ADDENDUM NO. 2

MAKUU OFFSITE WATER SYSTEM PHASE 2 PRODUCTION WELL, RESERVOIR AND SUPPORTING FACILITIES

HALONA, PUNA, ISLAND OF HAWAII, HAWAII

IFB NO.: IFB-13-HHL-002

SHEETS

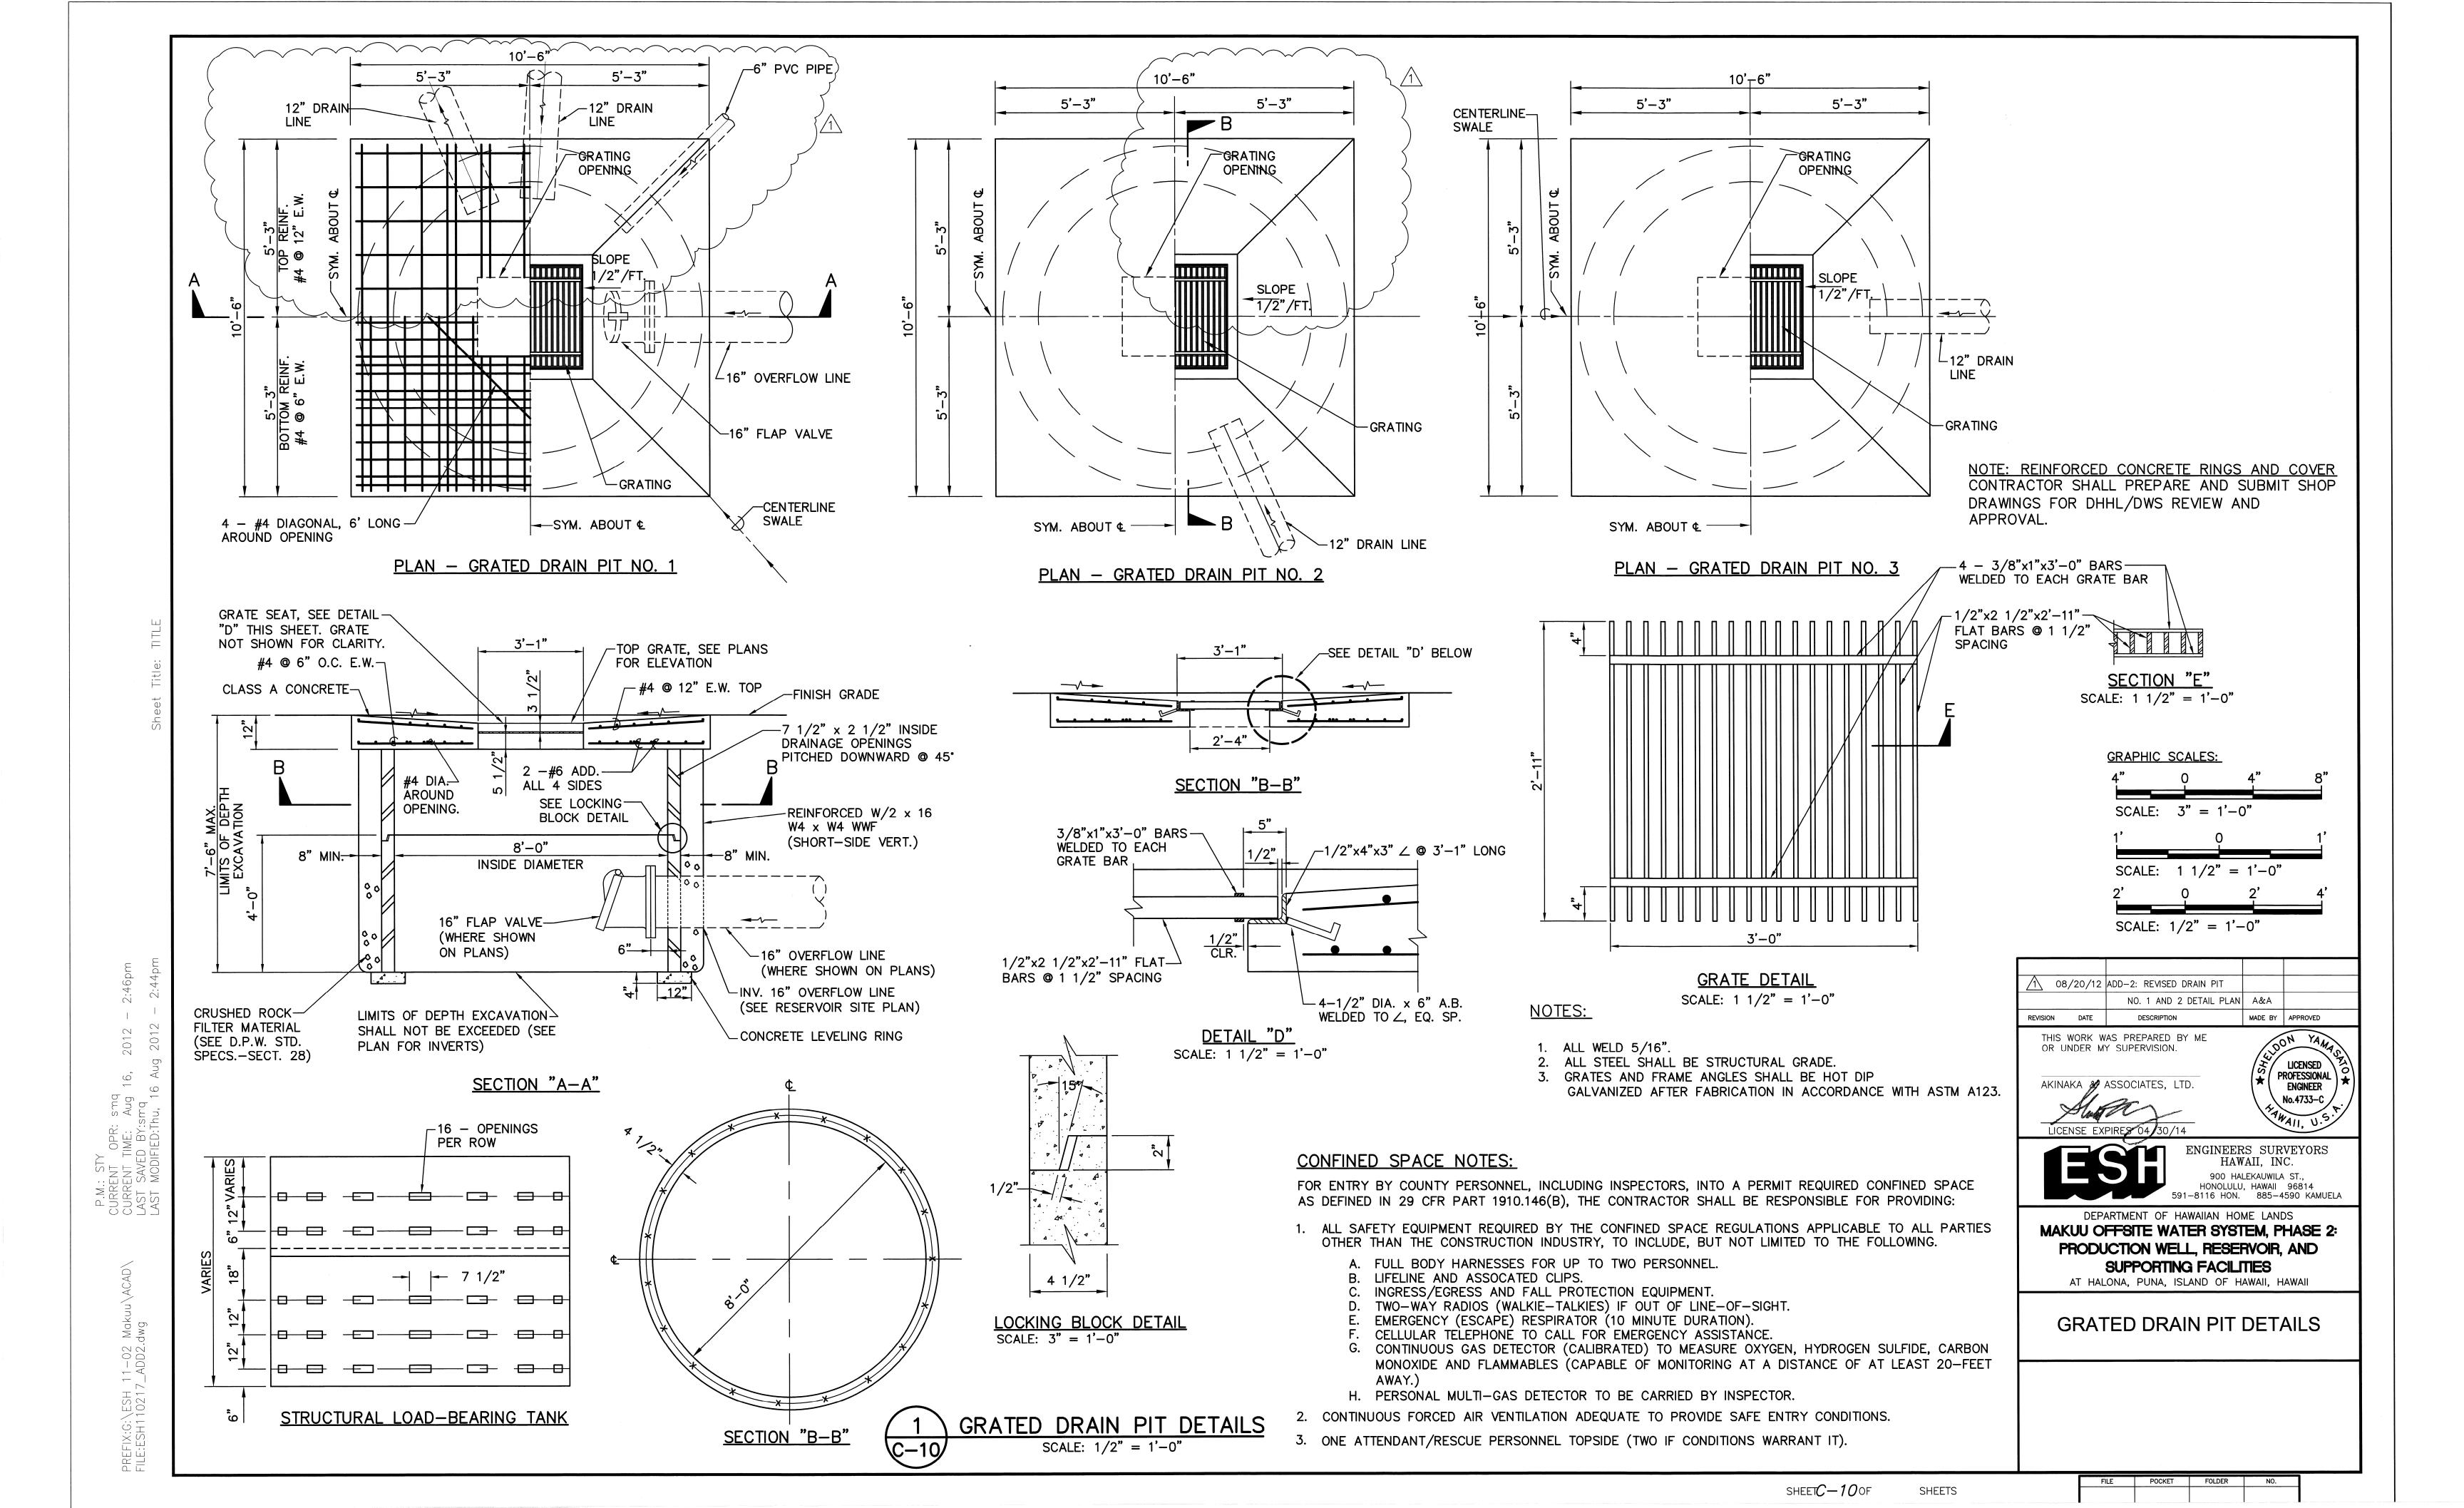
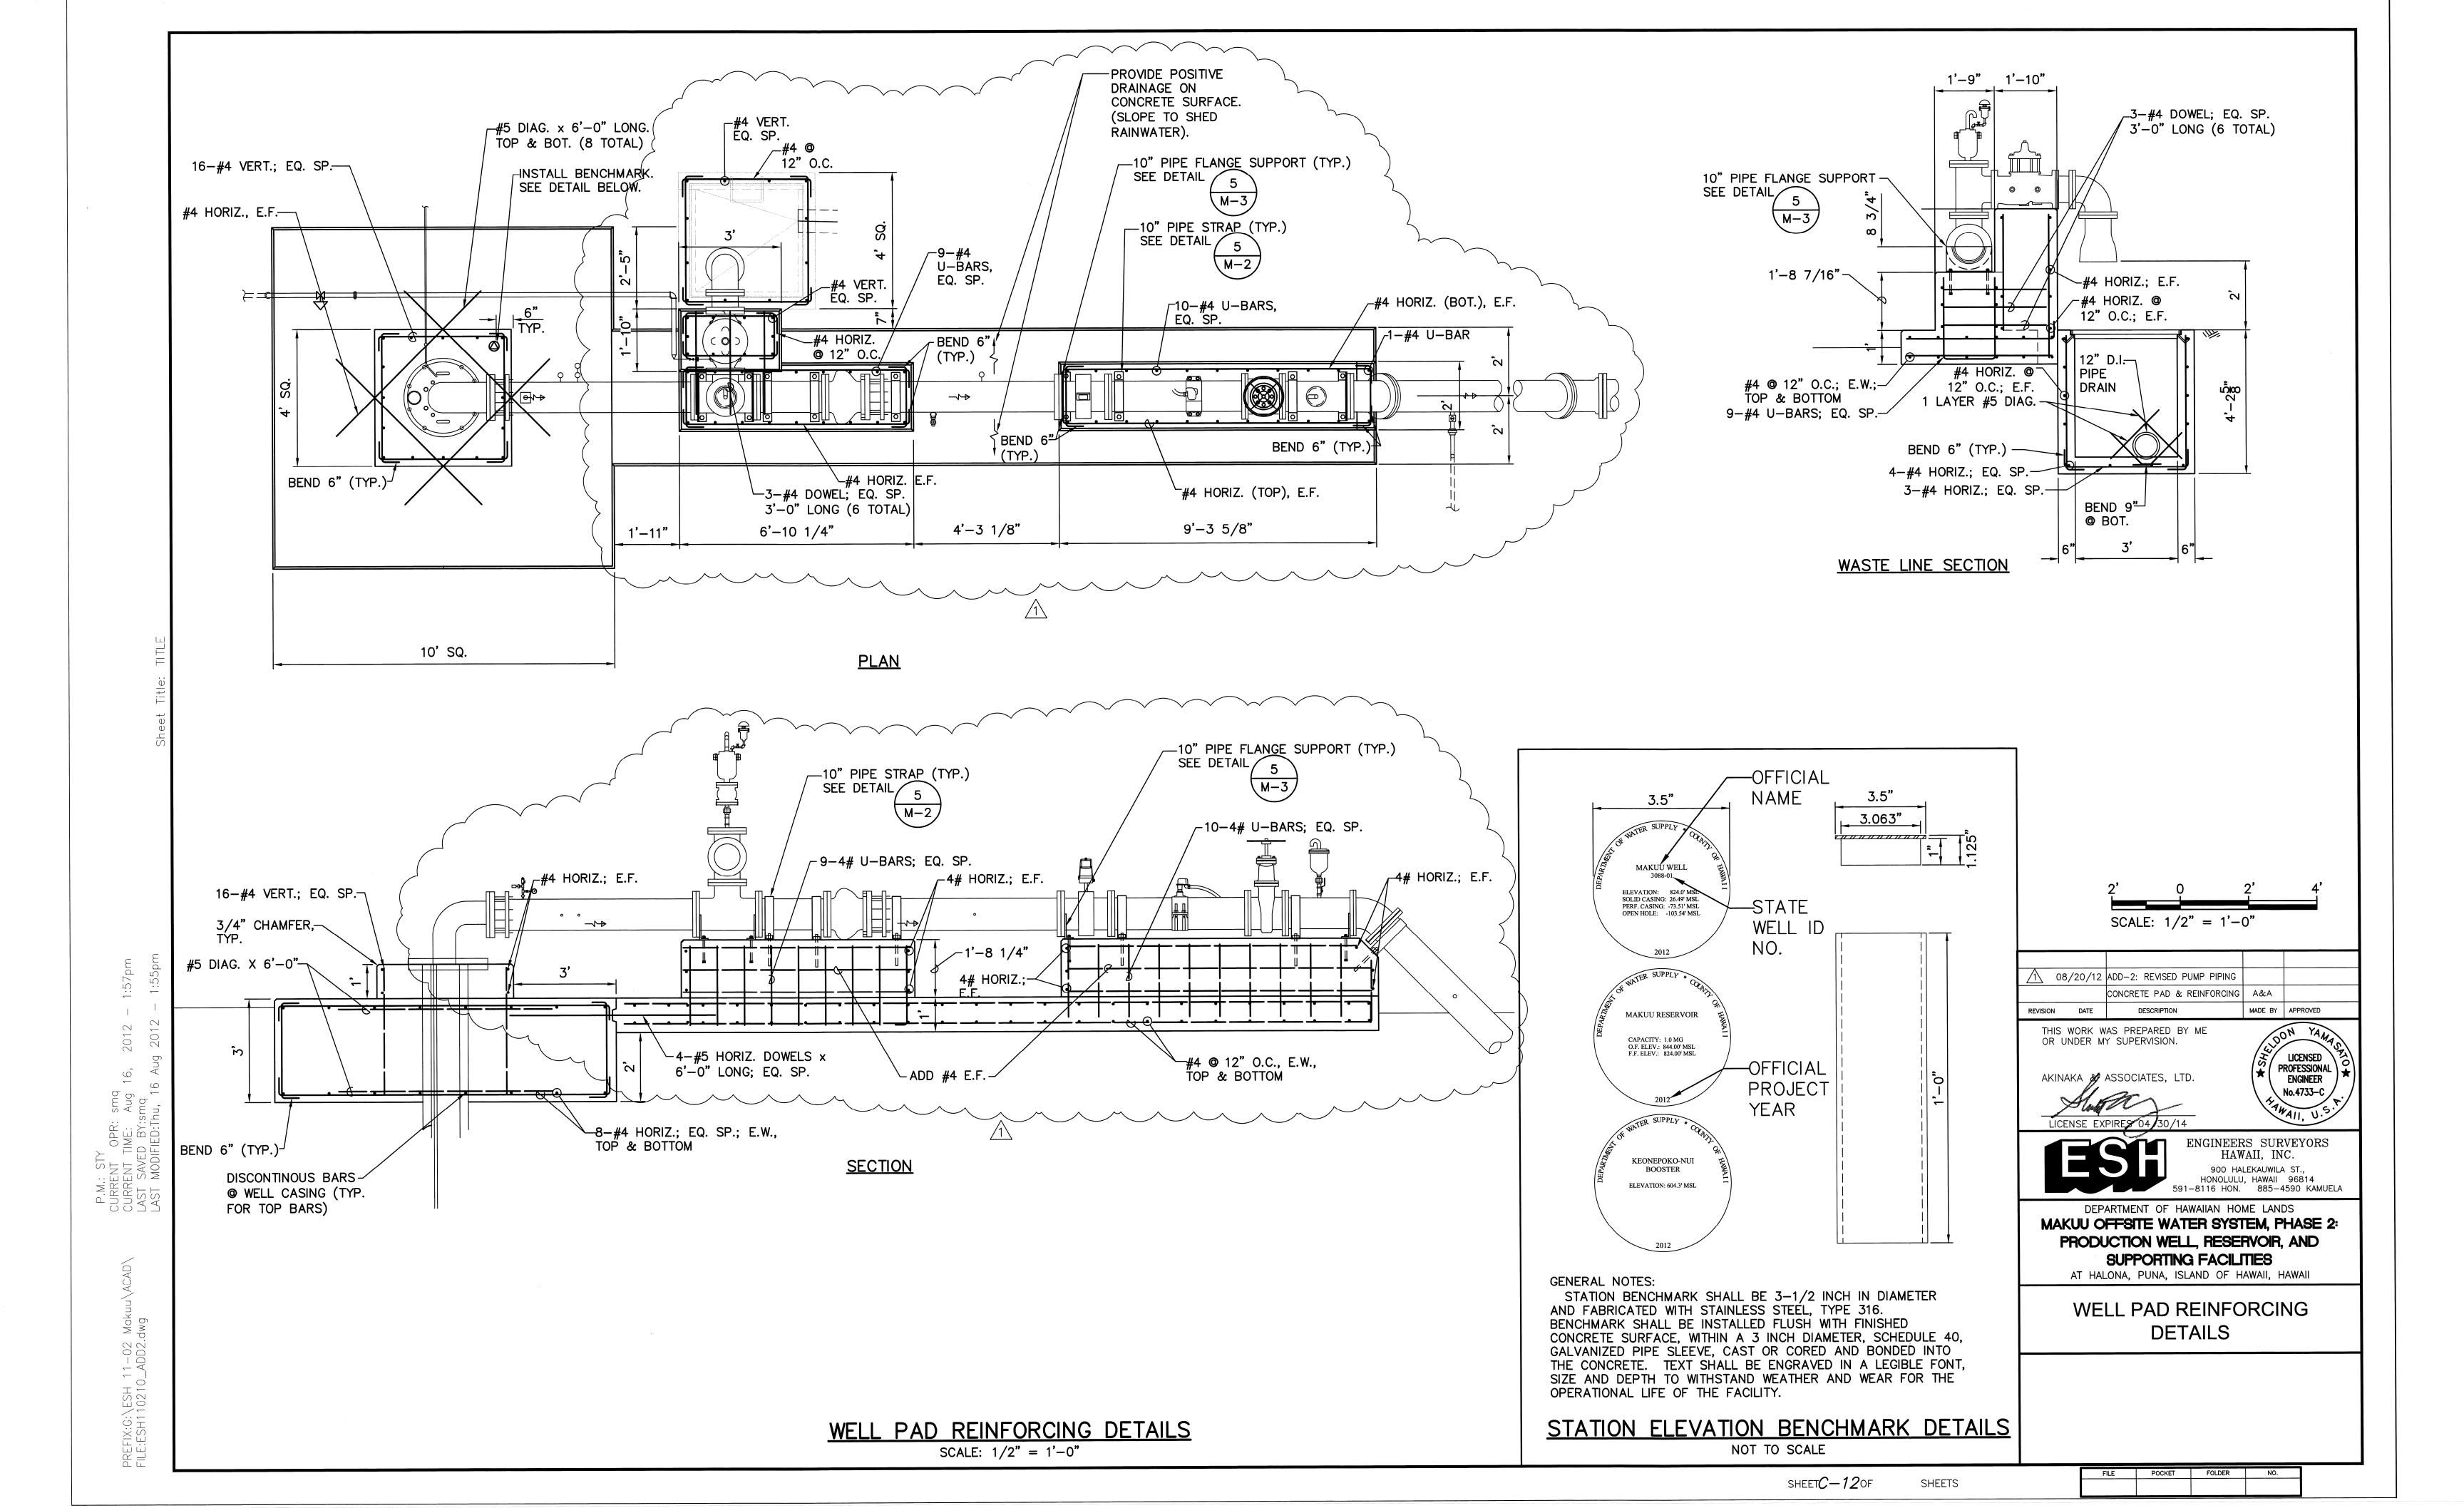
Proposal Item No. 40 of the subject project shows a proposal quantity of 3 each grated drain inlets, but we are only able to locate 1 each of the drain inlets (Note No. 35 on Sheet C-6).

Proposal item 40 has been revised in this addendum, there is only one drain inlet. Sheet C-6 has been revised in this addendum.

sheetC-15of sheets

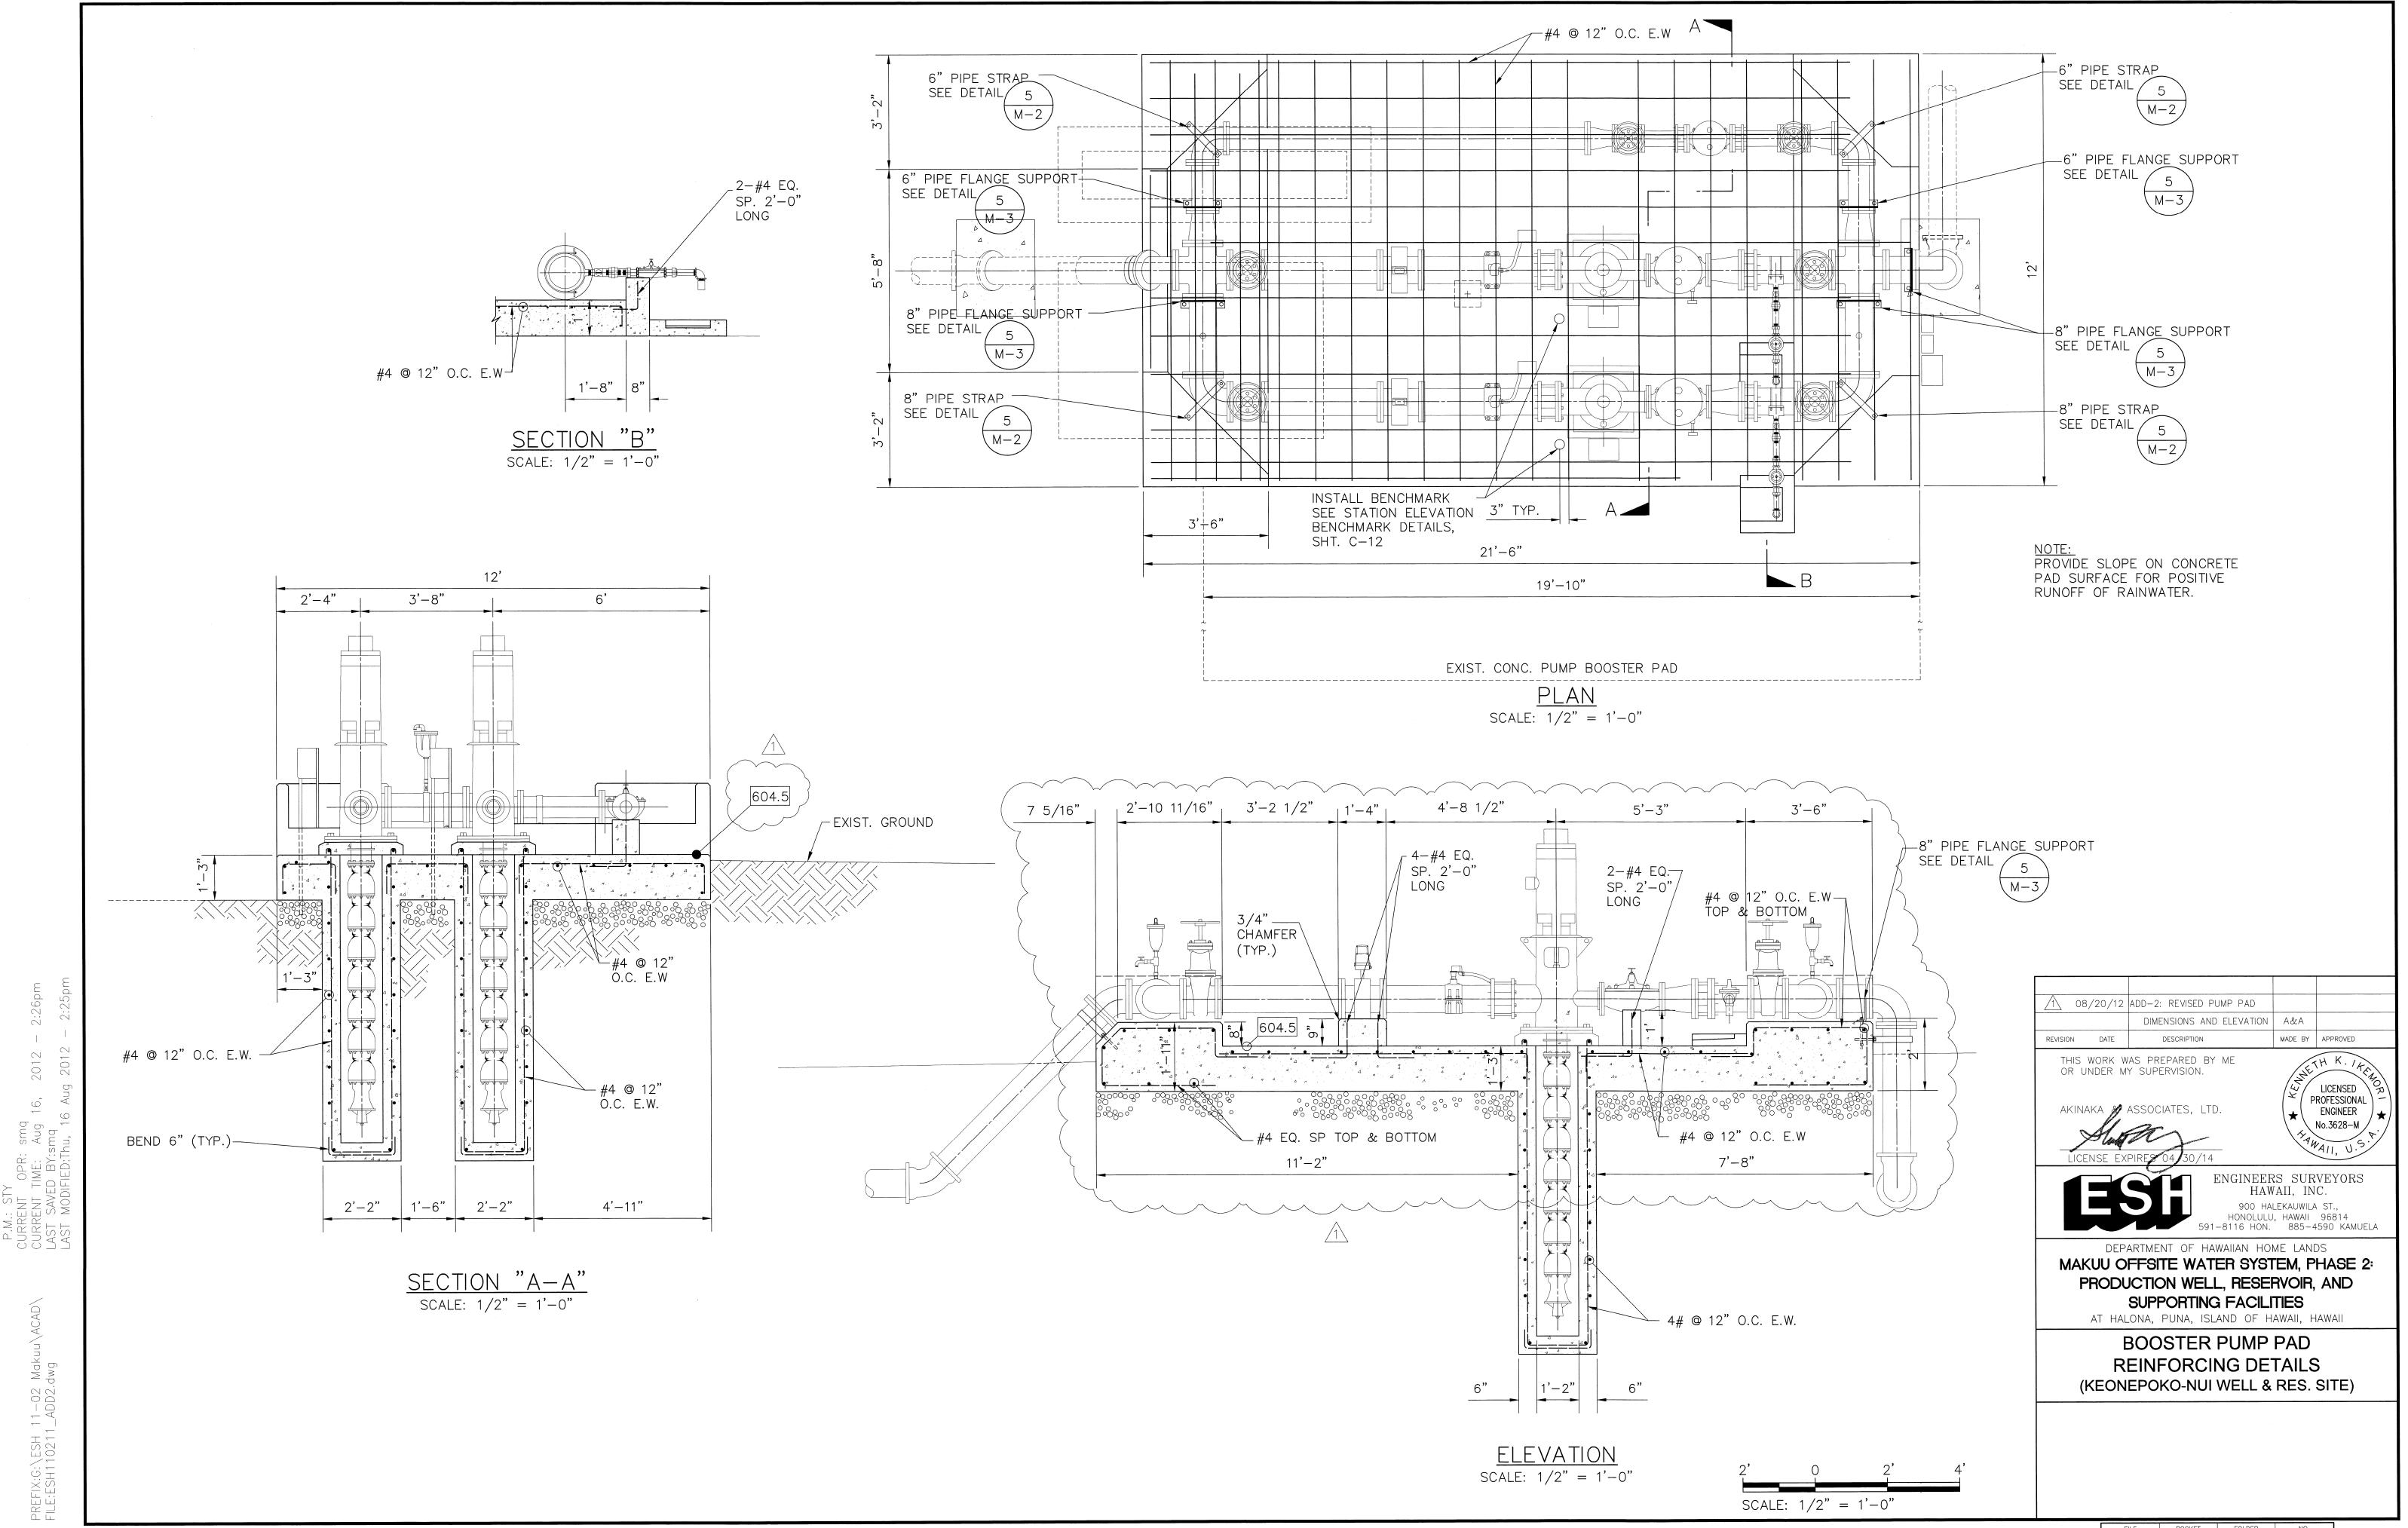
The dimension callouts of the elevation view of Sheet C-15 for the booster pump pad appears to be incorrect.

The dimension callouts have been revised on Sheet C-15, Addendum No. 2.
